SAFETY DIRECTIVE/ALERT SD-111521-C

SUBJECT:	Slipping Autopilot Bridle Cable Clamps		
AIRCRAFT AFFECTED:	MODEL: A5		
	S/N:	00139-00142, 145, and 149	
REQUIRED ACTION:	Disable autopilot system.		
TIME OF COMPLIANCE:	Complete before next flight

Figure 1: Remove inboard bridle cable clamp.

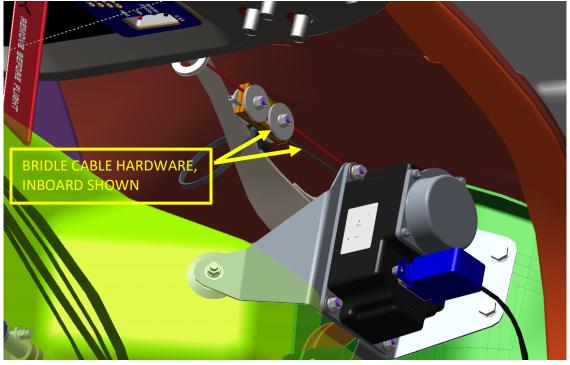
- 4. Loosen and remove the screws, nuts, and washers that secure the inboard bridle cable clamp to the upper roll cable. See **Figure 1**. Discard the clamp halves and the hardware.

Figure 2: Remove bridle cable clamps.

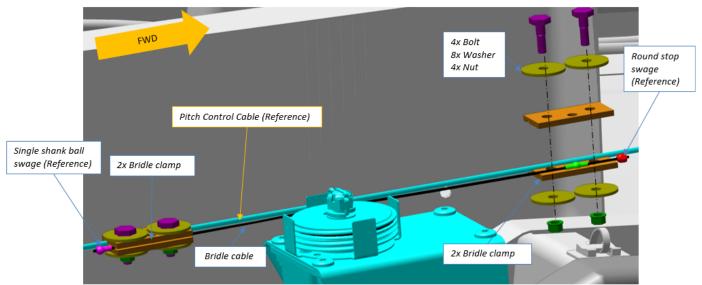
- 6. Loosen and remove the screws, nuts, and washers that secure the outboard bridle cable clamp to the upper roll cable. Discard the clamp halves and the hardware.
- 7. Loosen and remove the screws, nuts, and washers that secure the bridle cable clamps to the upper pitch control cable. See **Figure 2**. Discard the clamp halves and the hardware.

Figure 3: Loosen and Remove hardware

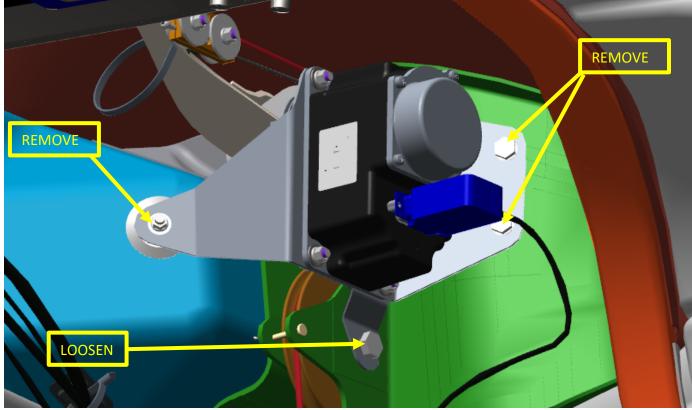
- 8. Disconnect the control harness connector, D9140P, from the roll servo
- 9. Disconnect the control harness connector, D9148P, from the pitch servo.
- 10. Remove the 2 bolts that secure the roll servo bracket to the left-hand center wing root rib. Retain hardware for reinstallation. See **Figure 3**.
- 11. Remove the nut and washer that secure the roll servo bracket to the stud bonded to the center wing spar. Retain hardware for reinstallation. See **Figure 3**.
- 12. Loosen the nut and bolt securing the upper roll cable pulley just enough so that the roll servo and the mount bracket can be removed as the bracket is slotted in this location. See **Figure 3**. Retain the roll servo and mount bracket for later reinstallation.

Figure 4:Remove hardware

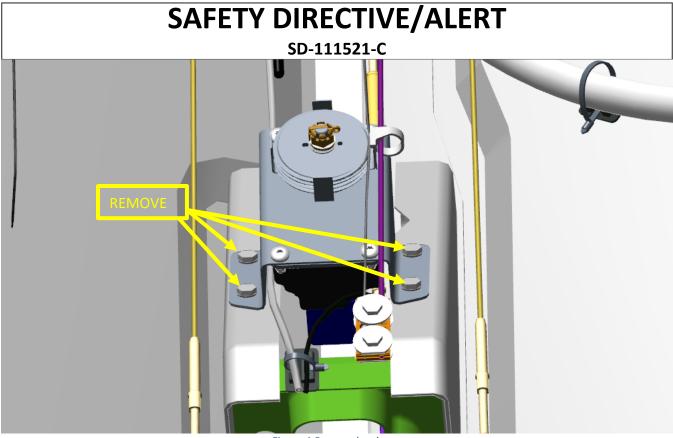
- 13. Remove the four screws and washers that secure the pitch servo and its mount bracket to the keel of the aircraft and remove the pitch servo and bracket. Retain the servo, bracket, and mounting hardware for later reinstallation. See **Figure 4**.
- 14. Remove the 5 Amp "AUTOPILOT" fuse located at the front of the fuse panel on the co-pilot side of the overhead console. Retain for later reinstallation.

Figure 6:Cap connectors with F4 tape

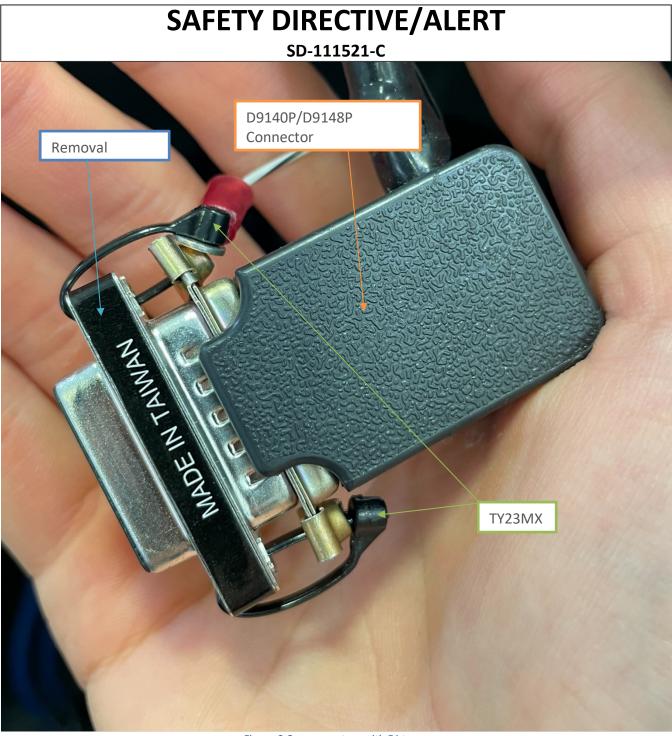
5. Install ICA014693, Removal Adapter (find number 22), onto servo connector, D9140P and secure in place with 2 each TY23MX cable ties. See **Figure 6**. Stow branch to wire harness using 1 each TY24MX in the approximate area indicated by flag note 34 in **Figure 5**.

Figure 7: Roll socket reassembly.

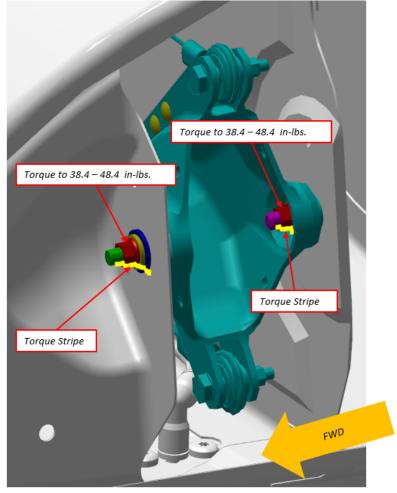
- 15. Tighten the nut and bolt that were loosened in step 12 to 38.4-48.4 in-lbs.
- 16. If removed, reposition the pilot side roll socket in place at the pilot-side end of the center wing and reinstall the mounting hardware removed in step 5. Torque and apply inspector's lacquer as shown in Error! Reference source not found.7. If the removal step 5 alternative method was used, reposition the upper roll cable bearing in the roll socket and reinstall the screw, washers, and

Figure 8: "INOP" label installation

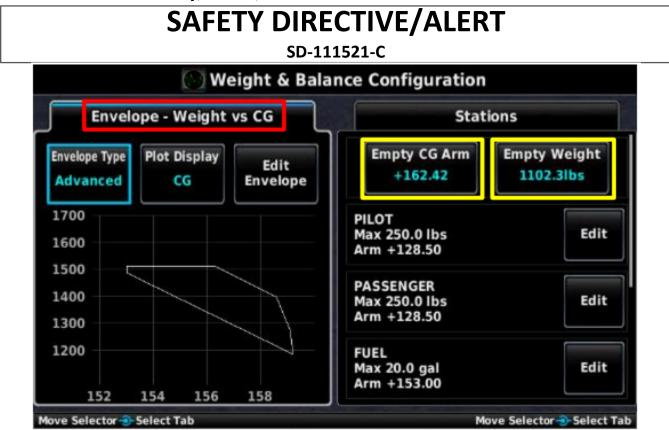
- i. Select "Save & Reboot" option on the bottom of the configuration menu
- 21. Apply a label displaying "INOP" to the center stack as shown in Figure 8.
